LIGHTNING

SERVICE BULLETIN No.007

PRODUCT MODEL	: CCS Lightning
BULLETIN TYPE	: Manufacturing Correction
MANUAL / SECTION	: Workshop Manual – Section 7
PARTS LIST REVISION	: N/A
EFFECTIVE DATE	: July 12, 2006
SUBJECT	: Generator Alignment
UNITS AFFECTED	: Any units purchased prior to July 1, 2006.
PARTS AFFECTED	: 1058994 – Generator bearing housing
TERMS & CONDITIONS	: N/A

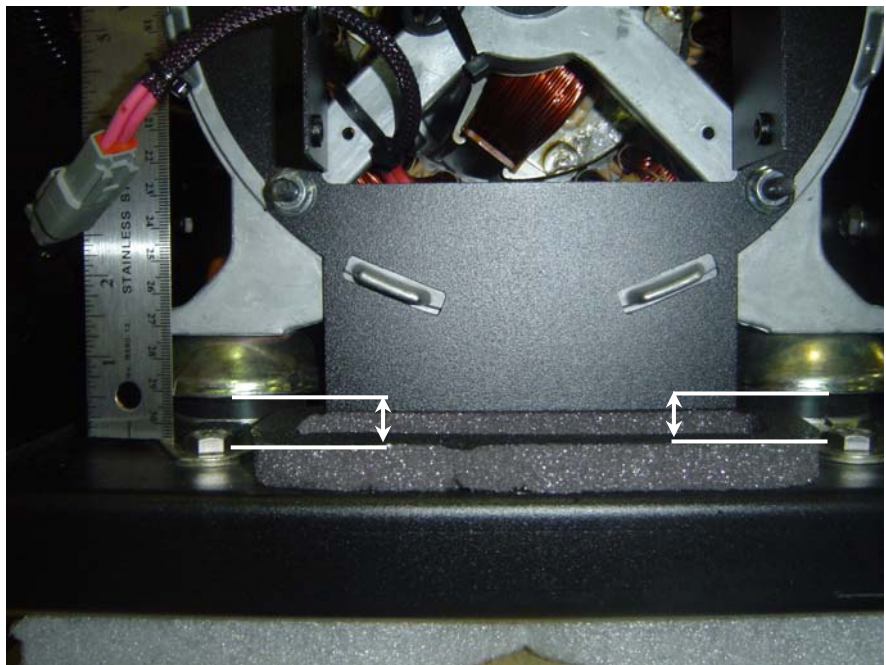
1. Remove 1069103 alternator cover assembly:

2. Measure and compare the isolator height by using a ruler to measure the distance from the bottom of the isolator cup to the base of the isolator (as shown). Compare the measurement between left isolator and right isolator.

If measurement differs by more than 1/16", proceed to 3. If not, install cover (no fault).

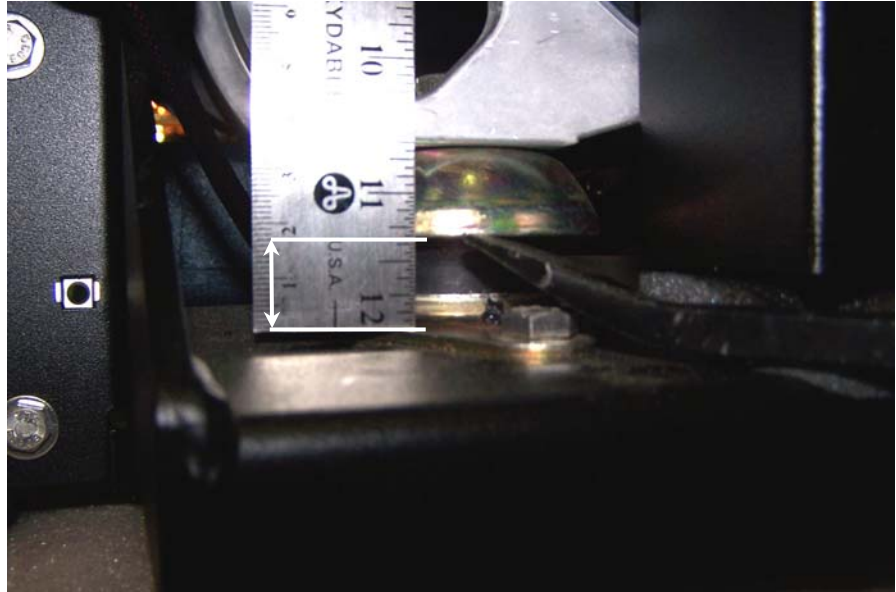
3. Verify the condition of the vibration isolator by using a pry bar. Pry up on the metal cup of the isolator. You should not be able to increase the height of the cup more than $11/16$ " (measured from the base of the isolator):

If prying on the cup increases the measurement by more than $11/16$ ", the isolator is defective and must be replaced.

Note: *The rubber is not bonded to the cup so the separation is normal.*

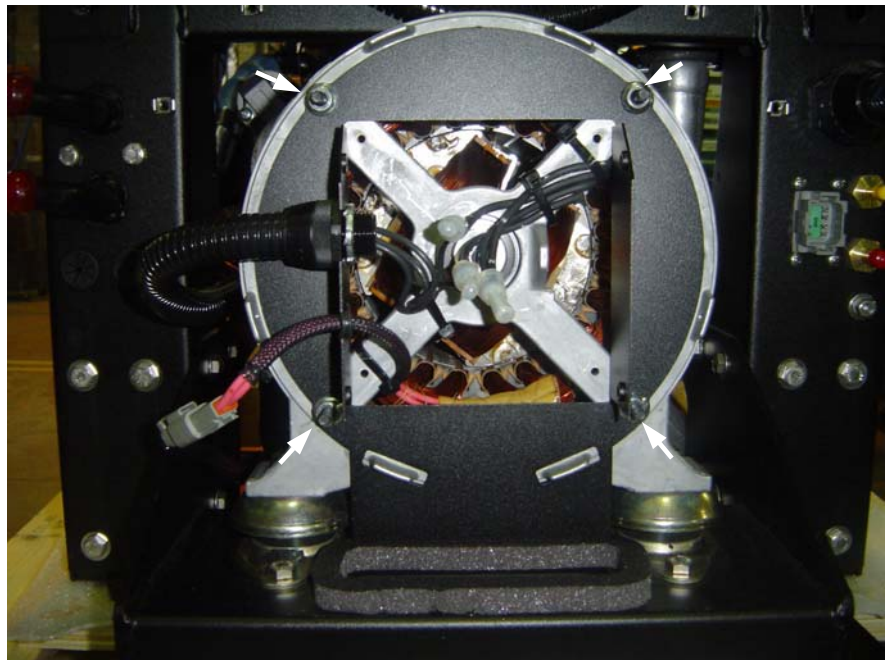
4. Loosen (four) nuts 1062531 that hold the Generator bearing housing.

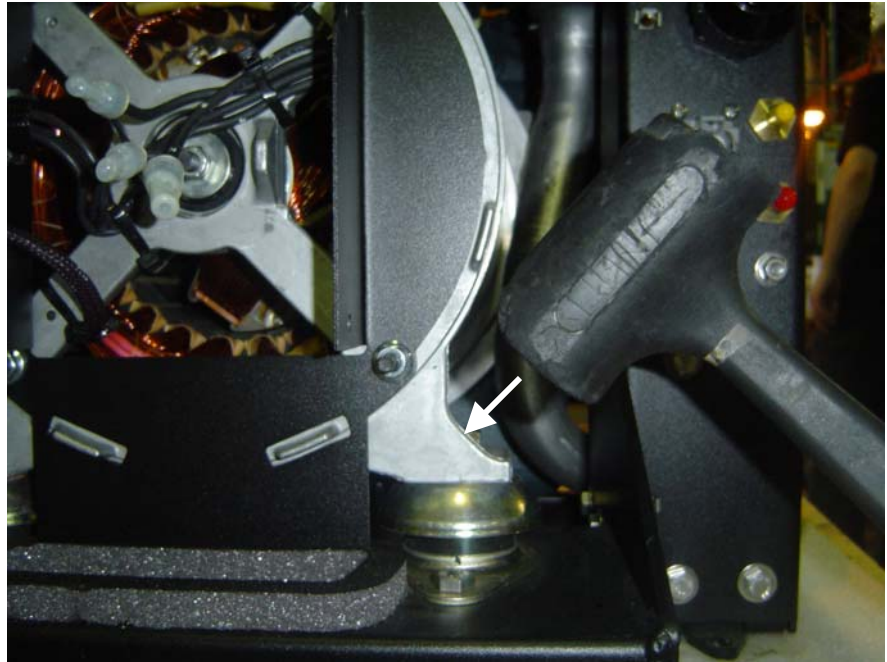
5. Using a dead blow plastic mallet, tap the generator bearing housing on the high foot until alignment is within specification.

6. Tighten generator bearing housing nuts to specified torque and install covers.
